Executive Director's Recommendation

Commission Meeting: April 6, 2017

PROJECT National Museum of Natural History – South Entrance Renovation 1000 Constitution Avenue, NW, Washington, DC	NCPC FILE NUMBER 7753
	NCPC MAP FILE NUMBER 1.24(38.00)44517
SUBMITTED BY Smithsonian Institution	APPLICANT'S REQUEST Approval of final site development plans
REVIEW AUTHORITY Federal Projects in the District per 40 U.S.C. § 8722(b)(1) and (d)	PROPOSED ACTION Approve final site development plans
	ACTION ITEM TYPE Consent Calendar

Final Site Development Plans

GRASS PANEL RAILING

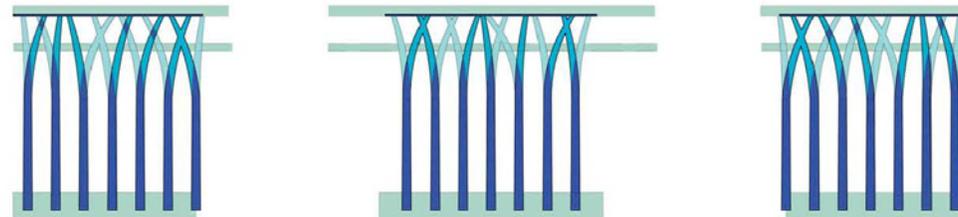
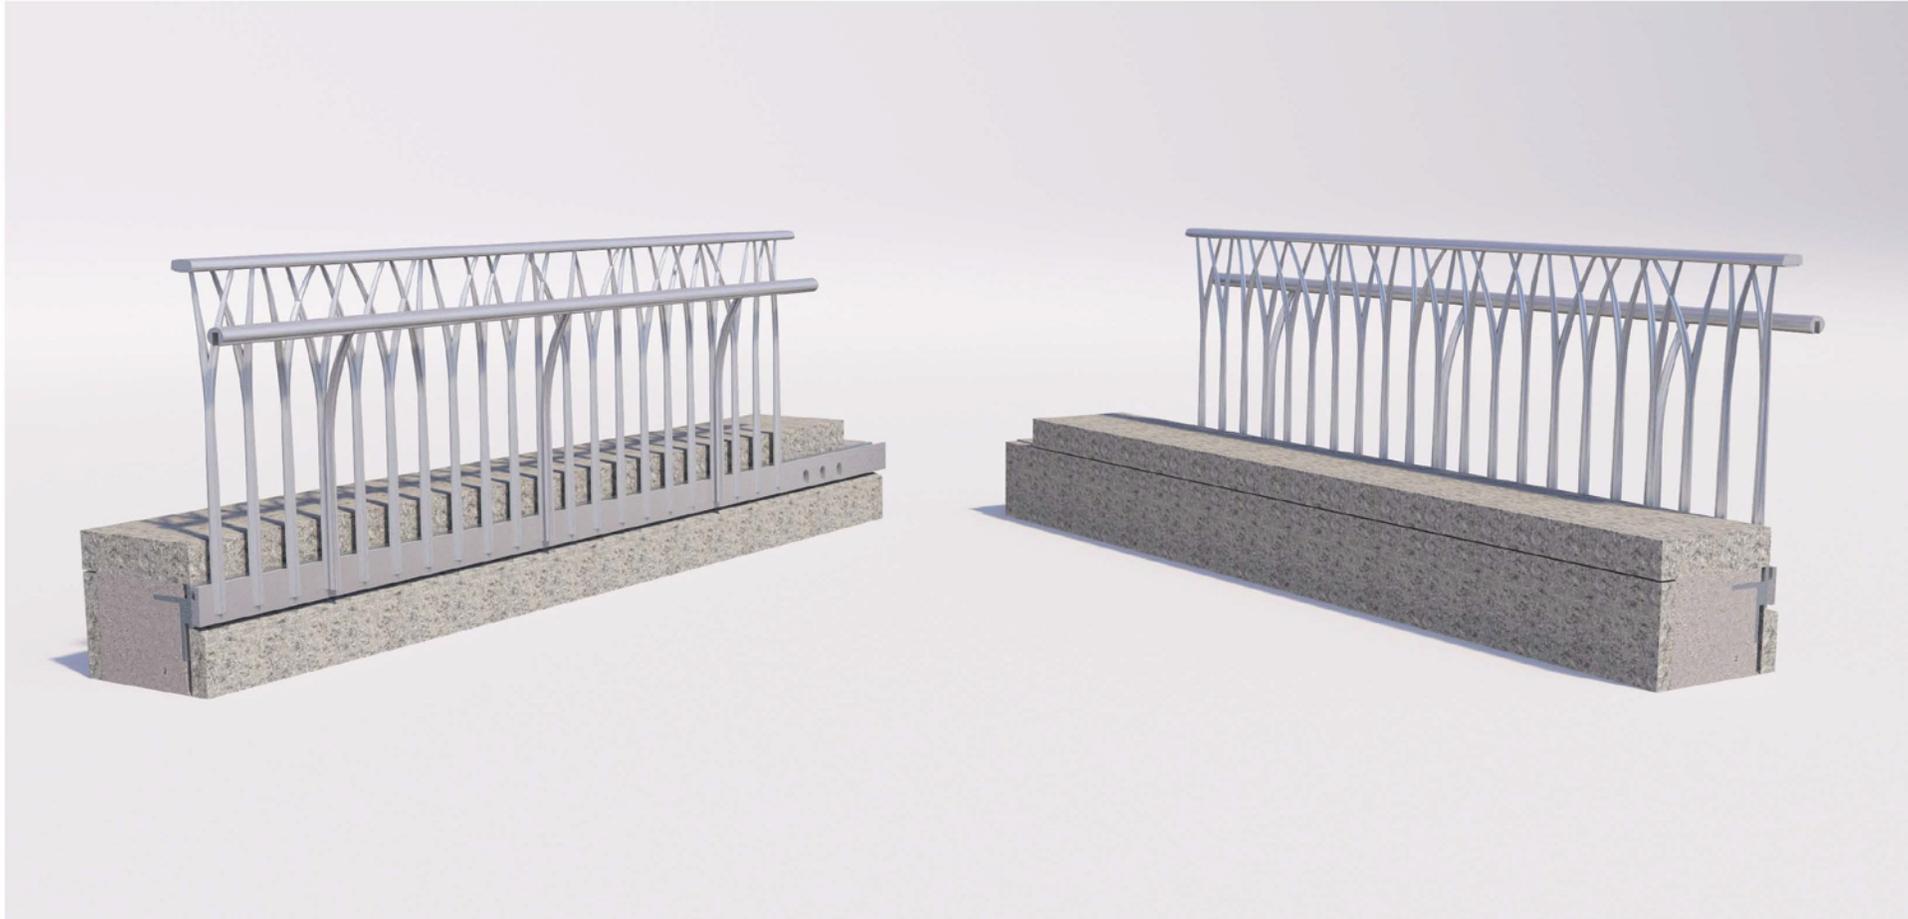
At preliminary review, the Commission approved the project and provided three comments regarding the proposed design. In response, the applicant has made several modifications. First, the Commission requested that the design of the handrails and stone base be further refined to reduce their visual prominence and increase compatibility with the historic museum building. In general, a simpler design approach is appropriate as it preserves the visual prominence of the historic museum building and allows the ramps to be complementary features. The applicant has

The guardrails have also been refined, while retaining their original grass-like form. In particular, the picket spacing has been increased to the maximum permitted by code and the inflection point for each grass "blade" has been shifted higher on the panel. The combined effect is a more transparent railing system that retains its reference to nature. Staff supports these changes.

DC SHPO concurred with the Smithsonian's determination stating "We consider the revised wall coursing to be much improved and, although we continue to advocate for a more traditional approach, we believe the "grass-like" handrails have been simplified enough to avoid an adverse effect." NCPC has elected to designate the Smithsonian Institution as lead agency pursuant to 36 CFR § 800.2(a)(2) to satisfy the Commission's Section 106 responsibility.

LIGHT DIAGRAM

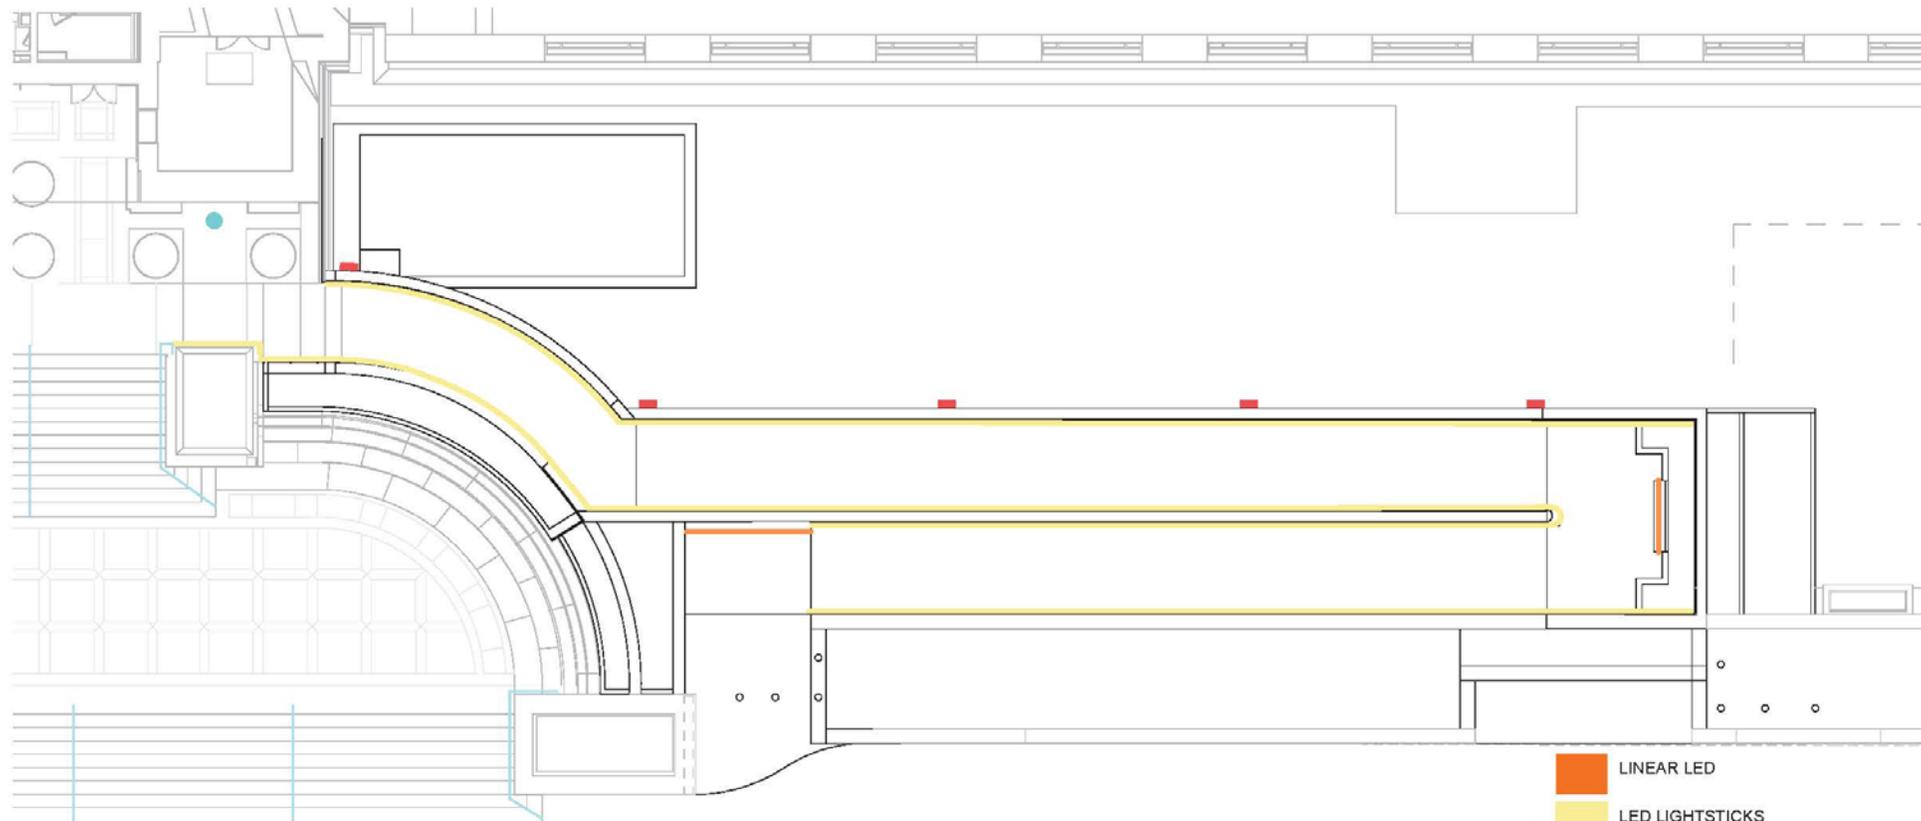
Secondly, the Commission recommended a lighting approach that is complementary to the historic museum building, while providing appropriate levels of illumination for safety and accessibility. The proposal includes three elements: linear LED lighting integrated into the ramp handrail; linear LED lighting located beneath the benches and signage; and lantern features located at the portion near the ramp landing. The applicant has provided additional drawings and renderings that confirm the lighting will remain subdued while preserving the prominence of the museum building. As such, staff supports the lighting approach.

WALL MATERIAL PALETTE

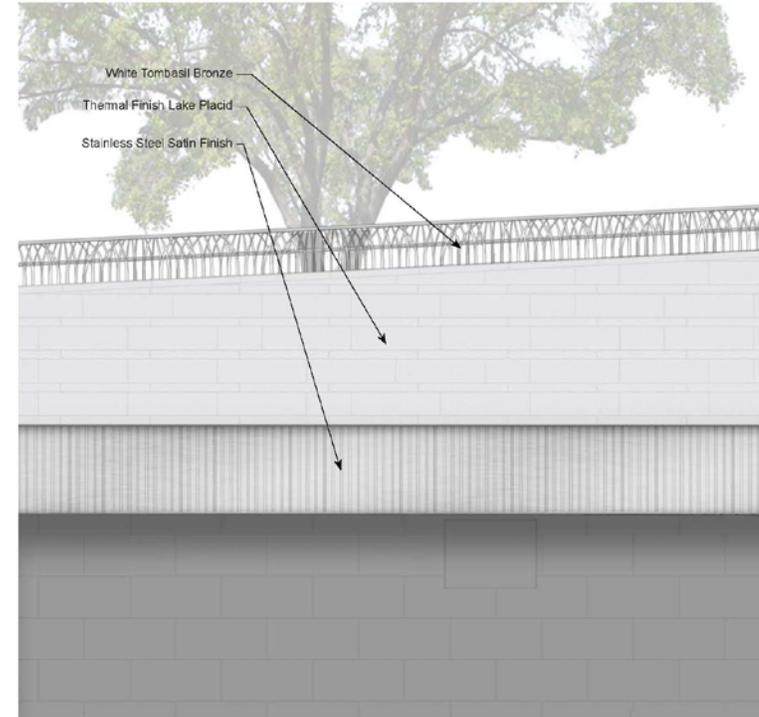
therefore simplified the masonry detailing of the ramp to be less prominent than previously proposed. In particular, only one stone (Lake Placid granite) is used, with subtle alternating coursing that relates to the coursing of the existing building. Simple letter is engraved into the stone at the entry to each ramp, indicating "Smithsonian Institution" and "National Museum of Natural History."
